BOARD OF APPEALS, CITY & COUNTY OF SAN FRANCISCO

Appeal No. **21-101**

NOTICE OF APPEAL

PRELIMINARY STATEMENT FOR APPEAL NO. 21-101

Figure 1: Site Plan Prepared by Appellants

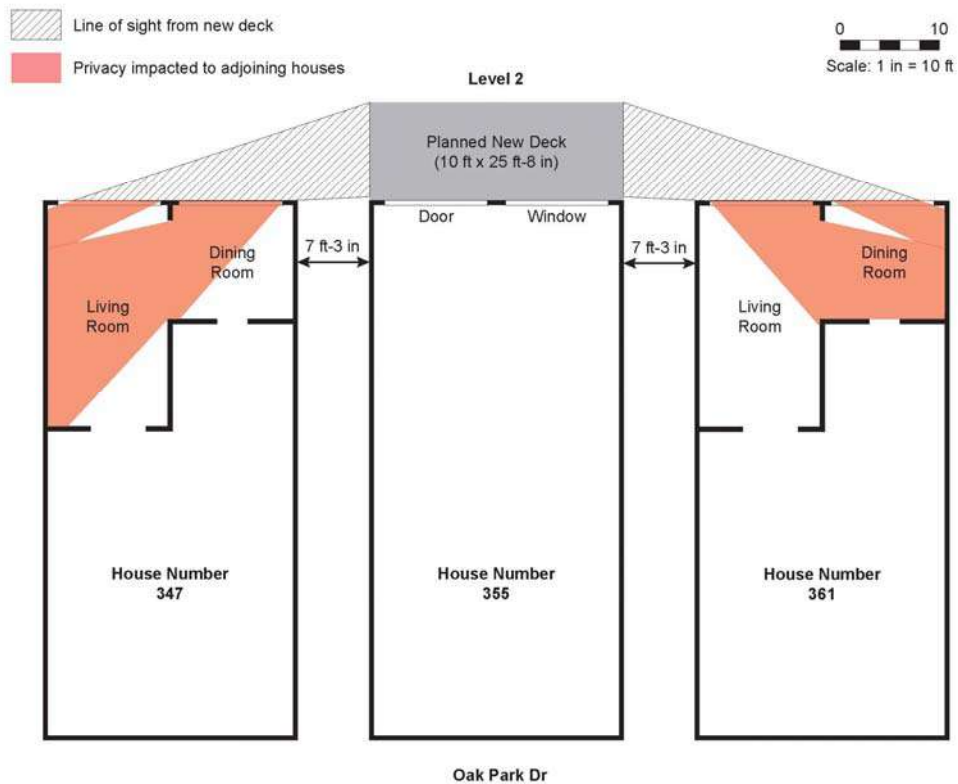
The Residential Design Guidelines require decks to be sensitively located and designed “with the smallest possible overall dimensions that meet the requirements of the Building and

1 Planning Codes.”¹ The Guidelines also require building expansions to “minimize impacts on
2 privacy.” (*Id.*, p. 15, 17; Planning Code § 101(c).) Similarly, the Planning Department has
3 recognized that decks may “have an unusual impact on privacy to neighboring interior living
4 spaces,” and modifications may be “appropriate depending on the circumstances of a particular
5 project.” (*Id.*, p. 17.)

The Appellants respectfully request that the permit be revoked or modified to reduce the size of the deck. In particular, the Appellants seek that the deck be reduced to a depth of five feet and pulled at least five feet from the side property line to preserve privacy for the Appellants' Properties.

27 *Figure 2: Diagram Prepared by Appellants*

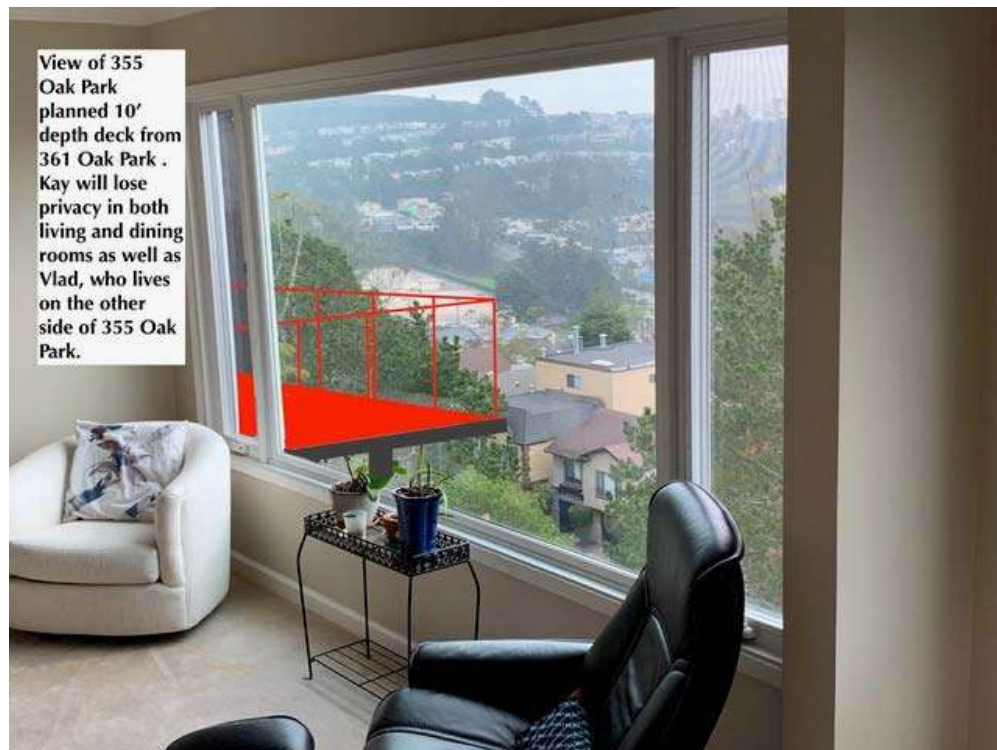
6
7 The Project does not comply with these principles because the deck facing the Appellants’
8 Properties will have an unusual impact on their privacy. (Declaration of Michael Garavaglia, AIA;
9 Declaration of Keiko Tsuyuki.) In particular, users of the deck will be able to look directly into
10 the Appellants’ primary living areas, as shown in the above diagram. The deck will only be 9-10
11 feet away from Appellants’ second story windows. The deck would also allow people to peer into

**Retaining wall
along back slope -
355 Oak Park.**

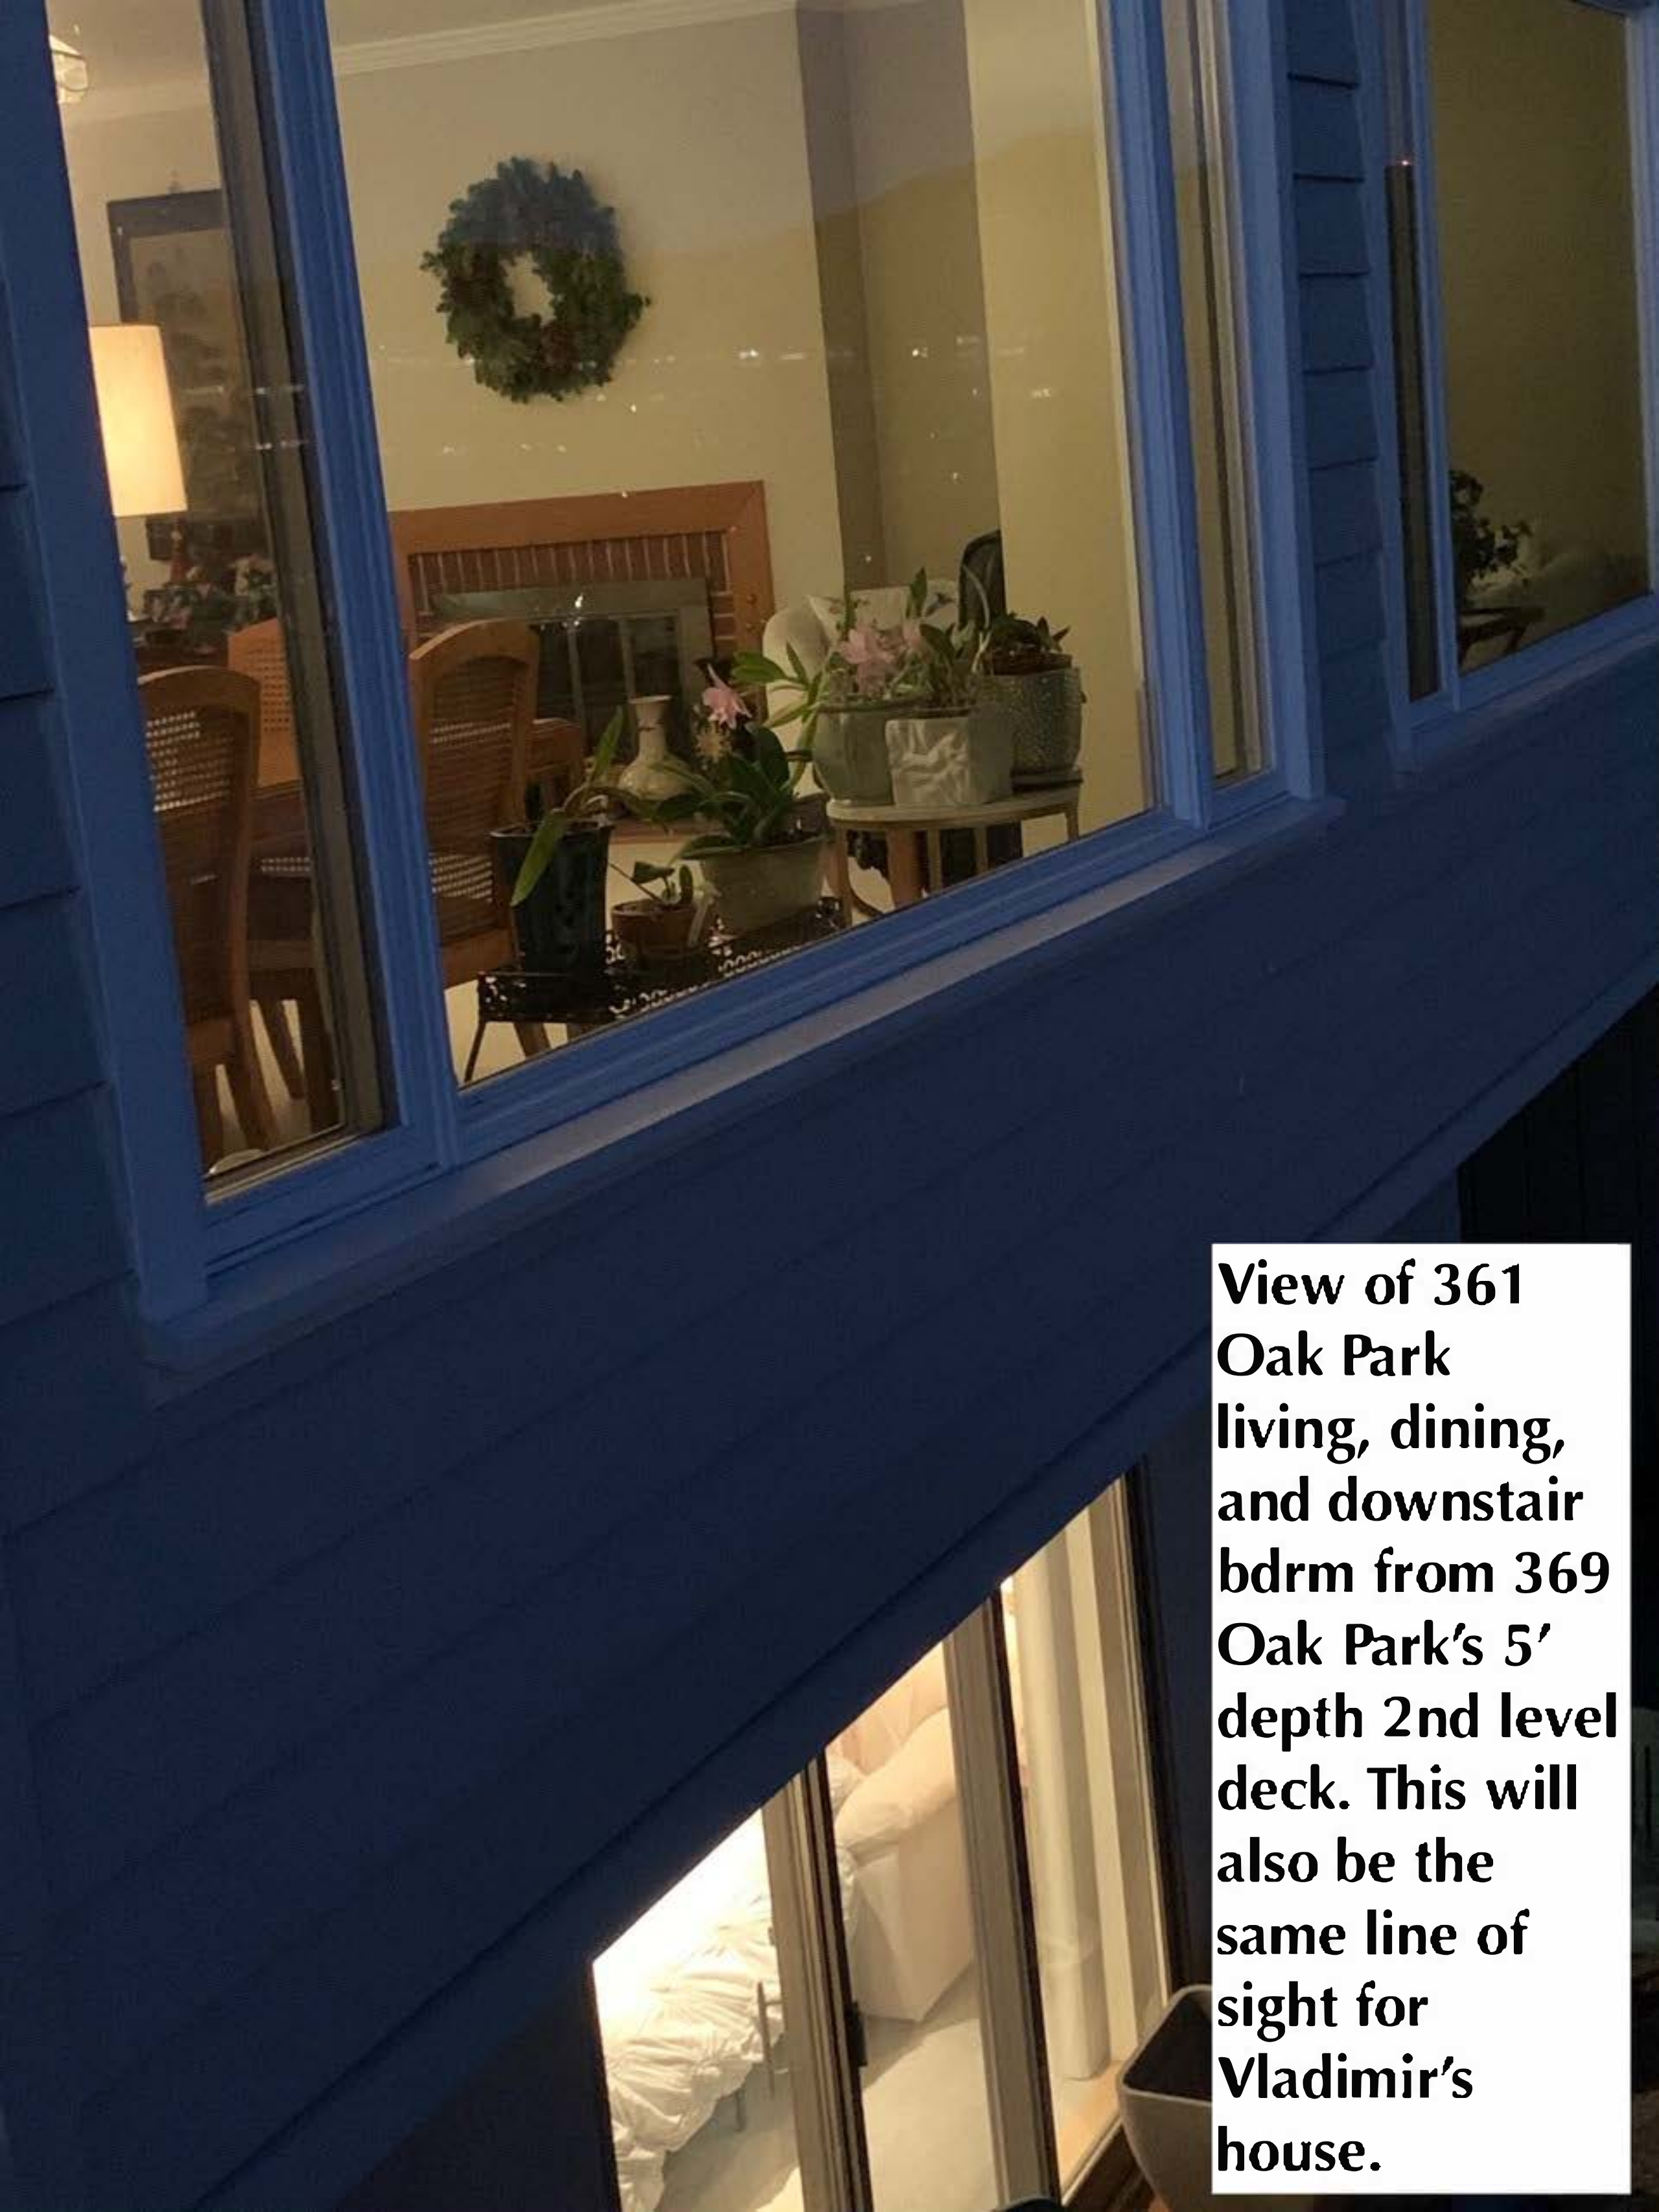
2nd level - 5' depth
deck - 369 Oak Park
as seen from Kay's
dining room

**View from 369
Oak Park's 5'
depth deck
into Kay's
living and
dining rooms.**

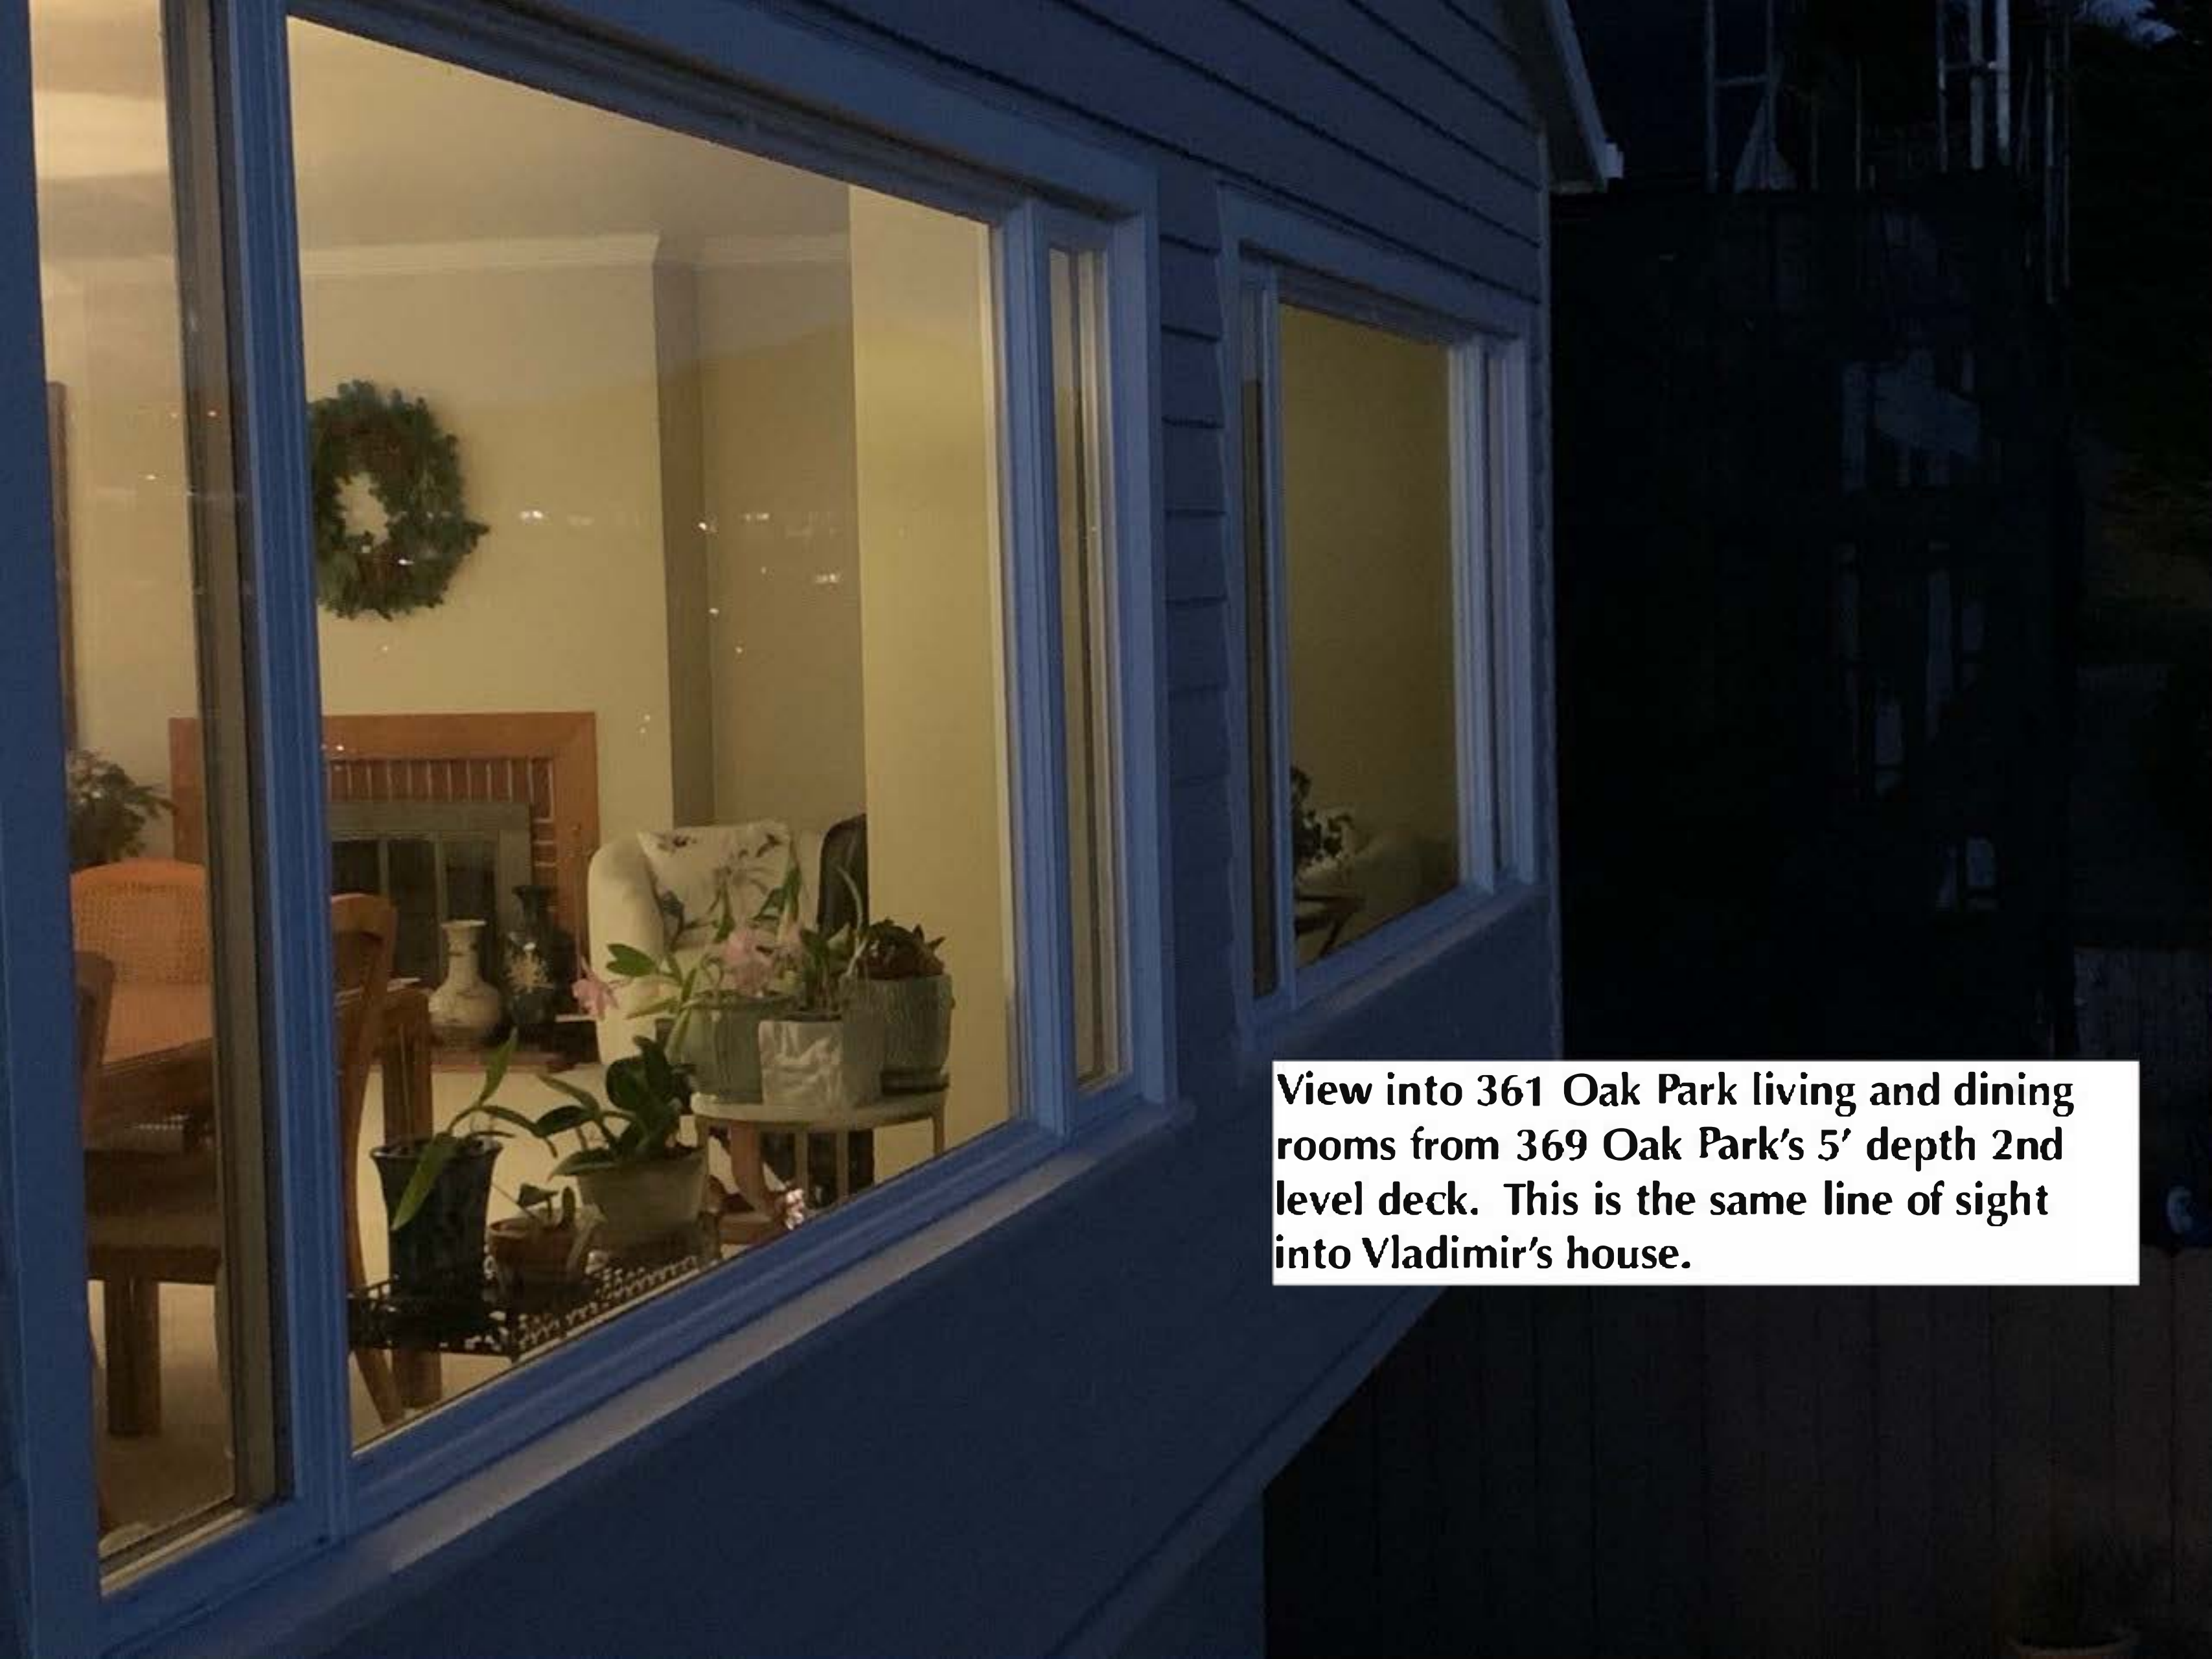
**View of 361
Oak Park
living, dining,
and downstairs
bdrm from 369
Oak Park's 5'
depth 2nd level
deck. This will
also be the
same line of
sight for
Vladimir's
house.**
